UNITED STATES PATENT AND TRADEMARK OFFICE

APPLICATION NO.	FILING DATE	FIRST NAMED INVENTOR	ATTORNEY DOCKET NO.	CONFIRMATION NO.
10/656,915	09/08/2003	Daniel H. Hazelton		8642
7590 11/16/2004				
Daniel H. Hazelton 55 Nunan Street Charleston, SC 29403		EXAMINER CHAMBERS, MICHAEL S		
		ART UNIT 3711 PAPER NUMBER

Office Action Summary	Application No. 10/656,915	Applicant(s) HAZELTON, DANIEL H.	
	Examiner Mike Chambers	Art Unit 3711

DETAILED ACTION

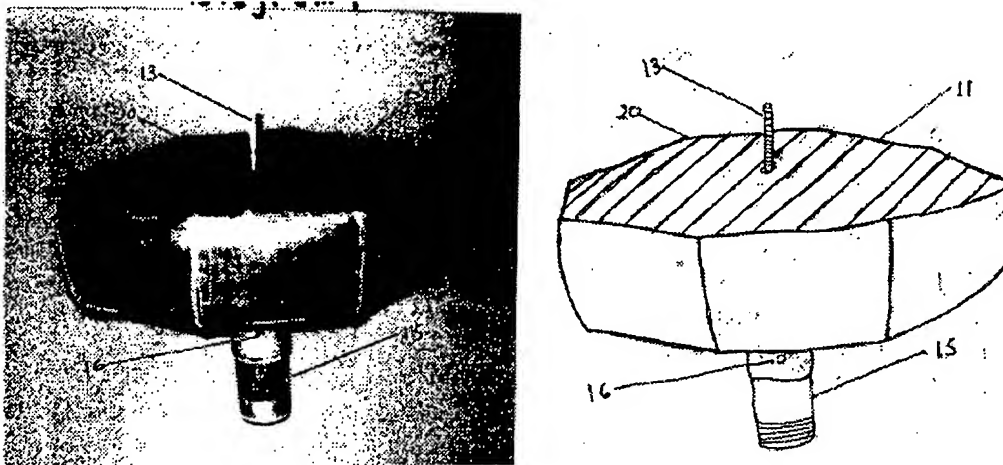
The amendment filed 7/28/04 is objected to under 35 U.S.C. 132 because it introduces new matter into the disclosure. 35 U.S.C. 132 states that no amendment shall introduce new matter into the disclosure of the invention.

The added material which is not supported by the original disclosure is as follows:

Fig 7 item 11 is disclosed as a planar surface.

Fig 7 item 13 is disclosed as a threaded rod.

Fig 7 item 15 is disclosed as a threaded pipe.

Applicant is required to cancel the new matter in the reply to this Office Action.

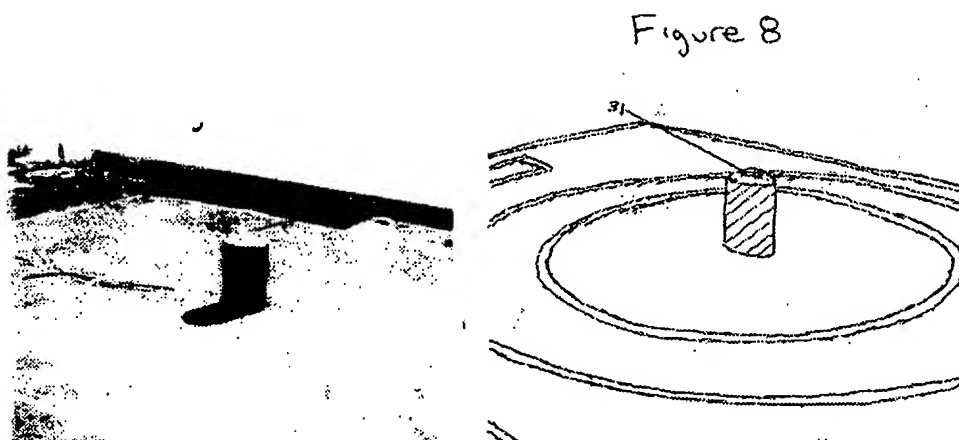
Fig 8 item 31 is disclosed

Fig 8 circular indicia is disclosed

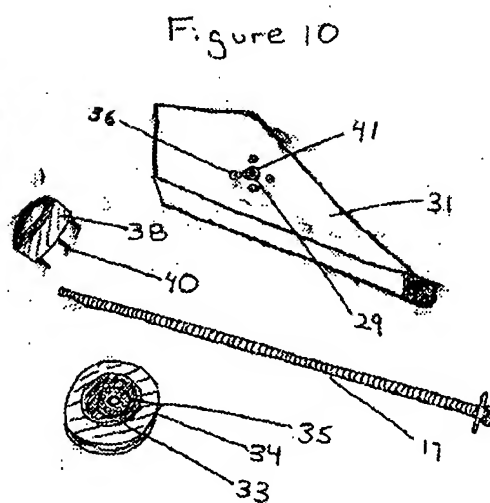
Fig 10 items 36,41,29,31,38,40,17 are disclosed.

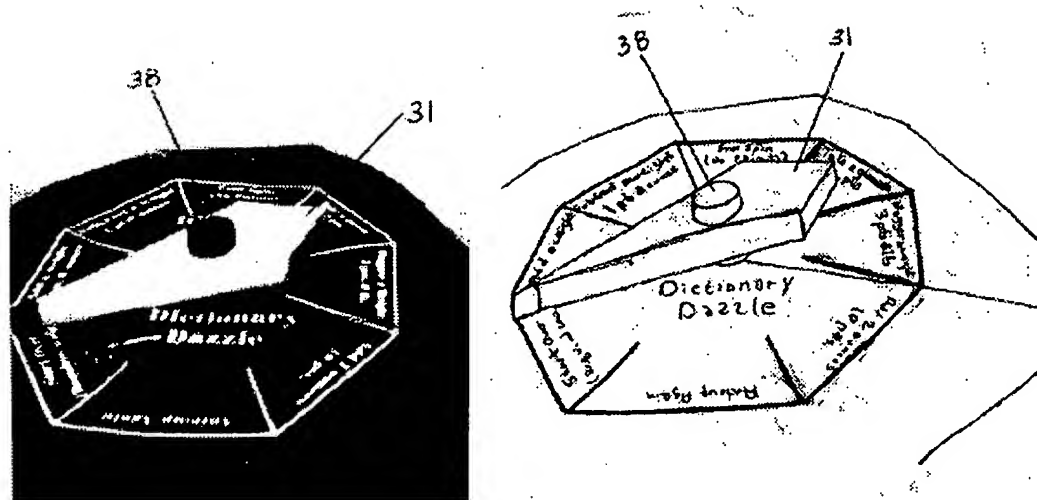
Fig 11 indicia is considered new matter
